MEMORANDUM

SUBJECT: Waterview North Sketch Plan Amendment
RE: Responses to CDOT Comments
PCD File No. SKP202.
LSC #204210

Waterview North Sketch Plan Resubmittal (April 2021)
LSC Responses to these CDOT comments.

WATERVIEW
 PROPOSED & EXISTING ACCESS EXHIBIT

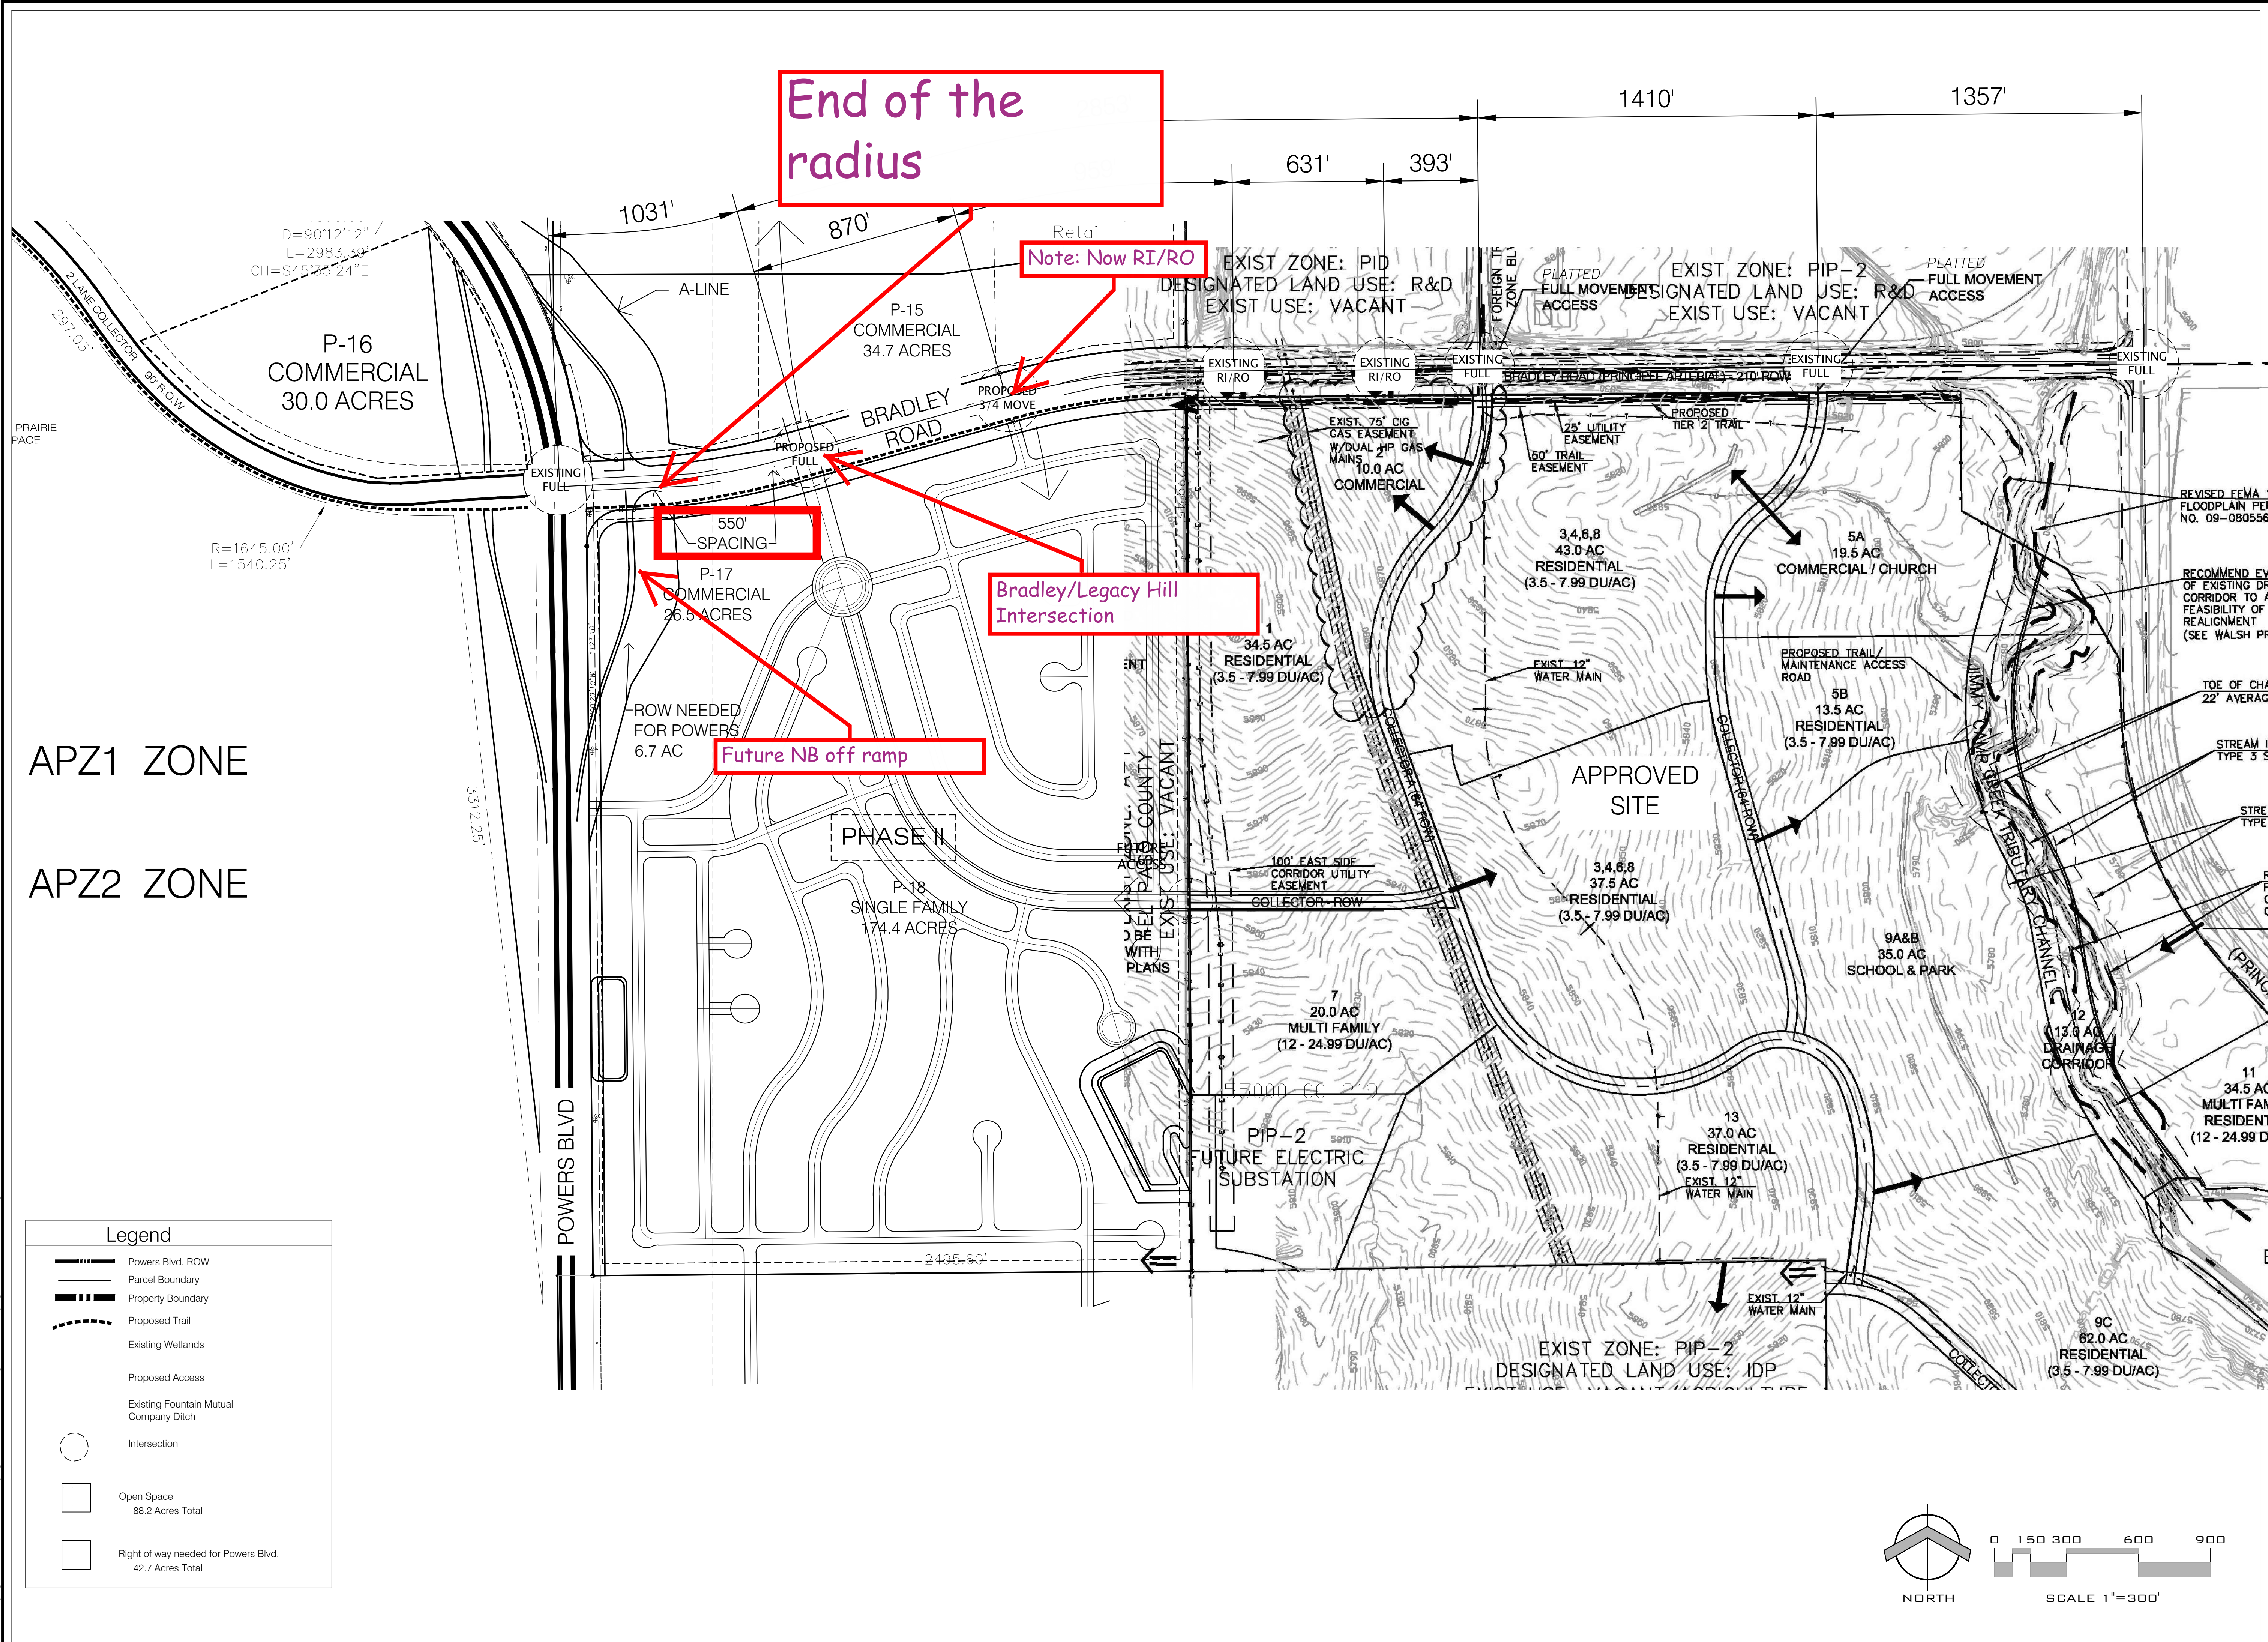
- h. The 2040 assumption of a six-lane Powers Blvd at Bradley overlooks the cost comparison of an interchange versus widening three miles of highway particularly with ADTs only at 40,000. The study should include an interchange alternative of 2040 traffic. Please update.  ¹
- i. Figure 19 depicts the long-term Bradley Road lane configuration east of Powers Blvd. It is clear from the drawing that the future eastbound left turn lanes for the future north side access will conflict with the future northbound ramp intersection. Please update.  ³

- b. State Highway Access Code, Vol 2, March 2002, Sec 2.13, Interchange Management Plan states; *any access in proximity to the interchange or potential interchange Access Rights should be obtained for a distance of 550-feet along the lesser street or crossroad measured from the radius point of the ramp touchdown curve.* It appears that the PUD Site Plan took this measurement from the centerline of existing SH21 to allow for the Legacy Hill Drive to obtain access from Bradley Rd. This does not comply with the State Highway Access Code and Will need to be revised.  ⁵

These are design details that can be addressed with the Preliminary Plan and/or when plans for the interchange are more developed. The partial side-by-side left turn lane configuration shown in this exhibit would not likely be needed with a diamond interchange configuration, therefore, the dual eastbound lefts into the site could likely be extended longer than shown in this exhibit, replacing the split single/dual configuration. This would likely shorten the length of the overall lane combination. Also, the northbound ramp could potentially be configured, if necessary, with two right turn lanes - one "free right" and one right turn with a tighter radius for traffic intending to turn left into Waterview North after turning right on Bradley.

This criteria was used to locate the access where it has been designed and approved by El Paso County. The location was confirmed in a County/CDOT meeting. The Legacy Hill Drive access location was adjusted from the originally-requested location specifically meet this 550-foot criteria. See attached excerpts from the March 28, 2017 ***Waterview Sketch Plan Updated Master TIS Springs at Waterview East Preliminary Plan TIS report and*** deviation request. The exhibits show measurement not from the centerline of existing SH 21, but from the end of the radius/radius point of the ramp touchdown curve. The access was placed specifically at this location east of the "A Line."
